Recall Bulletin

PRODUCT SAFETY RECALL

SUBJECT: Driver Door Switch Short Circuit

Note Statements have been added to Step 8 of the service procedure advising technicians to ensure that the protective coating is thoroughly mixed prior to application and that the ESD protective barrier is to be used during the application. Please discard all copies of bulletin 12180C.

2917380

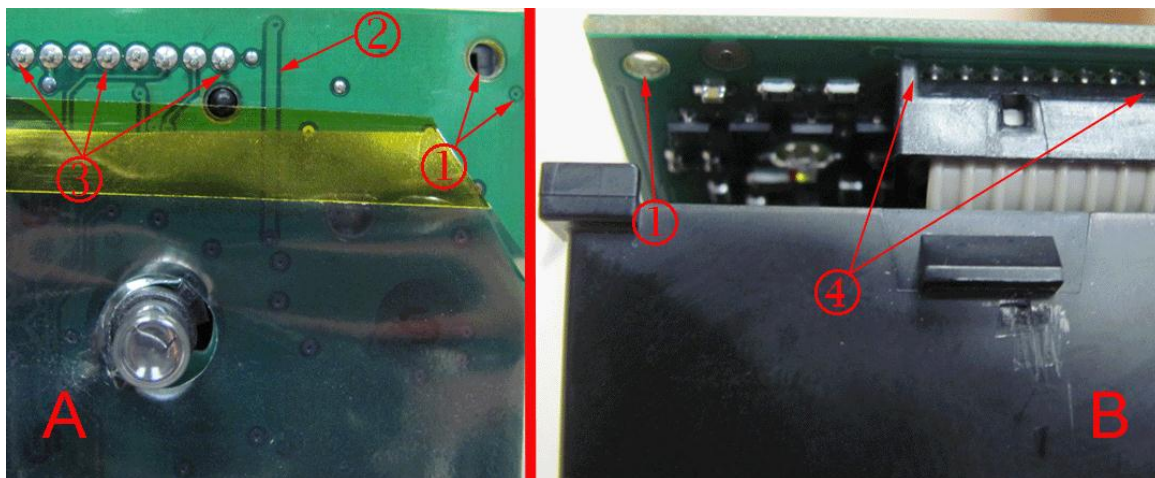
Note: Before removing the cap from the protective coating tube, squeeze/knead the tube to ensure that the contents of the tube are thoroughly mixed, Dispense a small amount of the protective coating on a clean piece of paper to ensure that the material is a consistent dark blue color.

Note: Do not substitute paper or cardboard for the ESD protective barrier.

Note: Do NOT attach the ESD protective barrier (8) over the connector pins (9).

8. Remove the backing paper from the ESD protective barrier (8) and attach it to the contact board. Attach the ESD protective barrier (8) along the edge of the connector pins (9). Refer to illustration.
9. Apply the protective coating to the top side of the contact board. Apply the protective coating over the entire length (10) of the contact board from the ESD protective barrier tape edge (8) to the contact board edge.
